### **CITY OF SEATTLE ANALYSIS AND RECOMMENDATION OF THE DIRECTOR OF THE DEPARTMENT OF PLANNING AND DEVELOPMENT**

**Application Number:** 3012437  
**Applicant Name:** Dean Kralios, SMR Architecture for Capitol Hill Housing  
**Address of Proposal:** 1620 12<sup>th</sup> Avenue

Land Use Application to allow a 6-story, 88 unit residential building with ground floor retail (3,893 sq. ft.), restaurant (2,431 sq. ft.) and performing arts theatre (9,484 sq. ft.) with 18,651 sq. ft. of office located on the 2nd floor. Parking for 115 vehicles as a part of a public facility (Seattle Police Department) will be located in below grade garage.

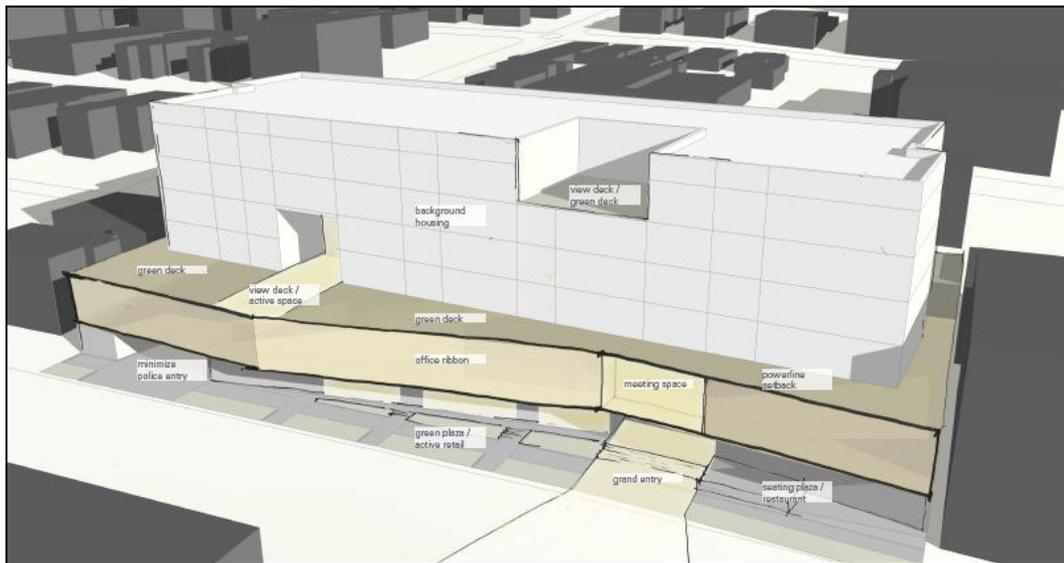
At the Early Design Guidance Meeting, the Board encouraged the three building forms of the preferred option to relate to each other and be perceived a part of one design concept. The Board enthusiastically supported the diagonal configuration of the upper levels as a sensitive solution to the zone edges.

The Board reiterated that where the building grounds itself is critical. The civic nature of the building and plaza space are special conditions and should create a physical “pause”

in the streetscape environment. The Board noted the important of balancing the grandeur and functionality of the building program and architecture.

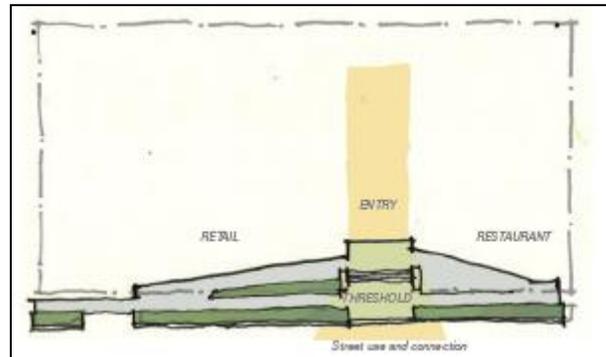
The Board noted that they will be interested in reviewing these details at the Recommendation phase.
